ADDENDUM NO. 5

April 20, 2023

North Central High School Additions and Renovations – Phase 3
1801 East 86th Street
Indianapolis, IN 46240

This Addendum consists of Pages ADD 5-1 through ADD 5-2, Pre-Award Schedule, Specification Section 00 31 00 Revised Indiana Bid Form, and attached Schmidt Associates Addendum No. 5.3 dated April 19, 2023, consisting of 14 Addendum Pages and 566 Addendum Drawings.

CL504.3

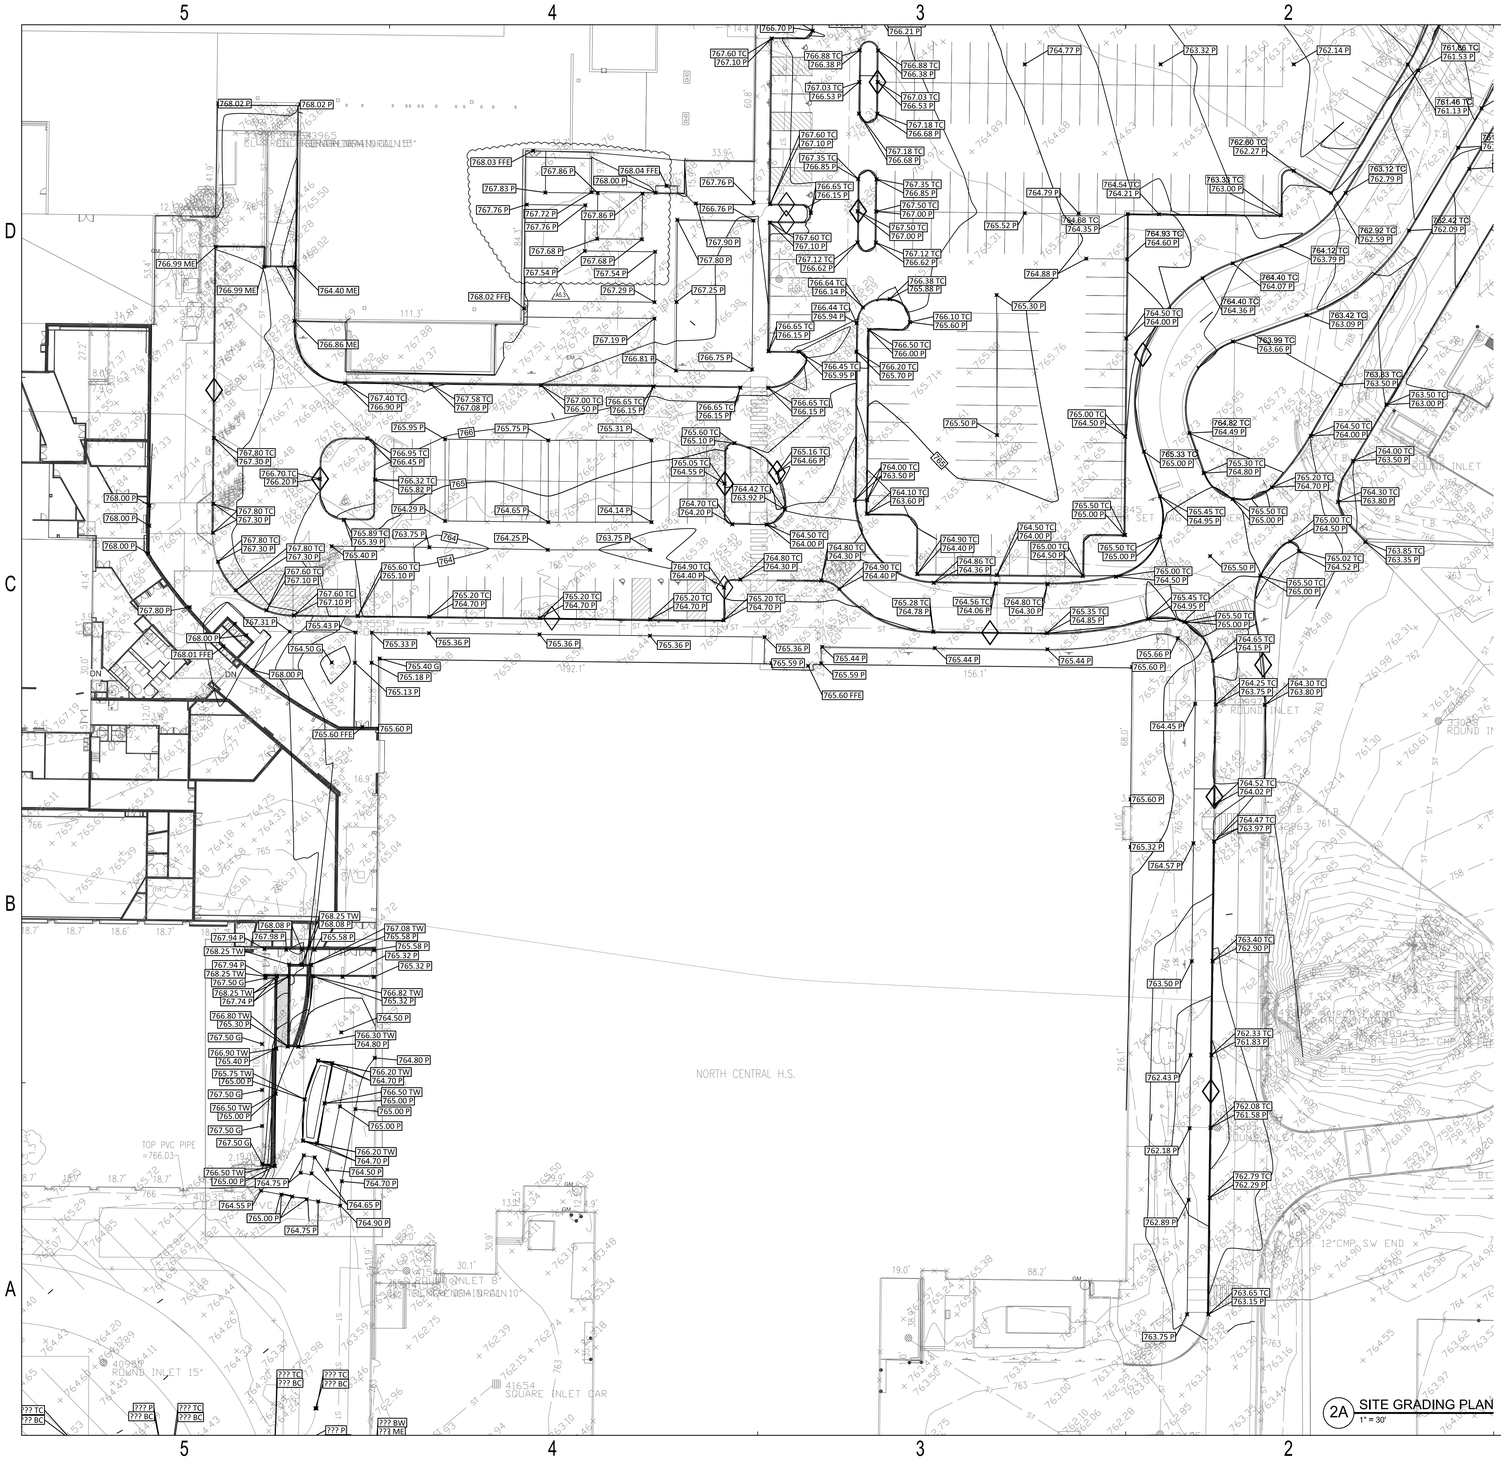
DRAWING NO.	INDICATE ACTION: ADD (A), DELETE (D), DELETE & REPLACE (R),
C-SERIES DRAWINGS	
CL103.3	DELETE AND REPLACE
CL504.3	ADD
CG103.3	DELETE AND REPLACE
CU101.3	DELETE AND REPLACE
S-SERIES DRAWINGS	
S-017.3	ADD
S-501.3	DELETE AND REPLACE
A-SERIES DRAWINGS	
A-003.3	DELETE AND REPLACE
AF1E2.3	DELETE AND REPLACE
AF1Q1.3	DELETE AND REPLACE
AF1Q2.3	DELETE AND REPLACE
AF1R1.3	DELETE AND REPLACE
AF1T1.3	DELETE AND REPLACE
AC1E2.3	DELETE AND REPLACE
A-405.3	DELETE AND REPLACE
A-415.3	DELETE AND REPLACE
A-510.3	DELETE AND REPLACE
A-511.3	DELETE AND REPLACE
I-SERIES DRAWINGS	
IN1H2.3	DELETE AND REPLACE
IN1K2.3	DELETE AND REPLACE
IN1K1.3	DELETE AND REPLACE
IN1C2.3	DELETE AND REPLACE
M-SERIES DRAWINGS	
MH1E2.3	DELETE AND REPLACE
MP1A1.3	DELETE AND REPLACE
MP1C1.3	DELETE AND REPLACE
MP1D1.3	DELETE AND REPLACE
MP1F1.3	DELETE AND REPLACE
MP1H1.3	DELETE AND REPLACE
MP1J1.3	DELETE AND REPLACE
MP1J2.3	DELETE AND REPLACE
MP1Q1.3	DELETE AND REPLACE
